REGULATORY OBSERVATION	
REGULATOR TO COMPLETE	
RO unique no.:	RO-ABWR-0043
Date sent:	16th March 2015
Acknowledgement required by:	8th April 2015
Agreement of Resolution Plan Required by:	<i>To be determined by the Hitachi-GE resolution plan.</i>
Resolution of Regulatory Observation required by:	<i>To be determined by the Hitachi-GE resolution plan.</i>
TRIM Ref.:	2015/99649
Related RQ / RO No. and TRIM Ref. (if any):	RQ-ABWR-0332 & RQ-ABWR-0409
Observation title:	Demonstration of the adequacy of pH control in the Suppression Pool during accident conditions
Technical area(s) 9. Reactor Chemistry	Related technical area(s) 5. Fault Studies 18. Severe Accident Analysis 4. PSA
Regulatory Observation	
SUMMARY	
<p>The objective of this Regulatory Observation (RO) is to state ONR's expectations with respect to Hitachi-GE demonstrating that the claims made in the Pre-construction Safety Report (PCSR) [1] relating to suppression pool pH control during accident conditions are adequately substantiated.</p> <p>The PCSR for UK ABWR makes a fundamental safety claim that the water contained within the suppression pool retains a significant fraction of iodine releases during accident conditions. I

Figure 1: Schematic of the Suppression Pool and related systems

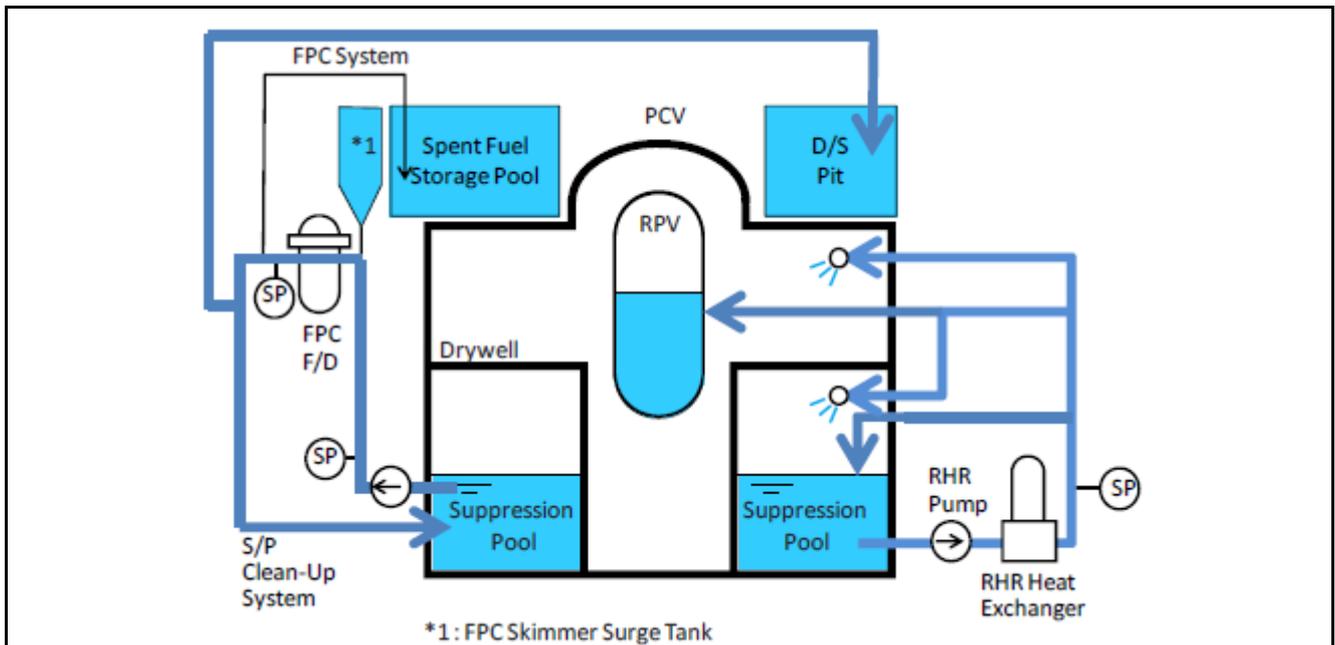
- As the suppression pool in UK ABWR is unbuffered the pH will be dominated by chemical species introduced during an accident, for example from fuel degradation products. These will include a wide range of species that could be both acidic or basic in nature. Any argument based on pH would need to consider these appropriately;

- The behaviour and speciation of iodine during the accident would be important, given the function of the pH control is to mitigate iodine releases, particularly if volatile organic iodine species form that are difficult to remove;

- The evidence which supports the claimed behaviour of iodine will need to be demonstrated to be suitable for conditions in UK ABWR (for example, under nitrogen atmospheres as opposed to air) and consistent with the current understanding of iodine behaviour in post-accident containments;

- The RP will need to present robust arguments and evidence to justify that the approach adopted for UK ABWR meets relevant good practice and reduces risks SFAIRP. [5] indicates that it is well-known that minimising volatile iodine requires the water solution containing iodine to be basic (pH > 7) as opposed to mildly acidic as suggested for UK ABWR.

RO-ABWR-0043.A1 – Hitachi-GE are required to provide a description of the safety case claims and arguments for suppression pool pH control under accident conditions.

RO-ABWR-0043.A2 – *Hitachi-GE are required to provide an evaluation of the pH change likely within the suppression pool for the various accident scenarios defined under Action 1.*
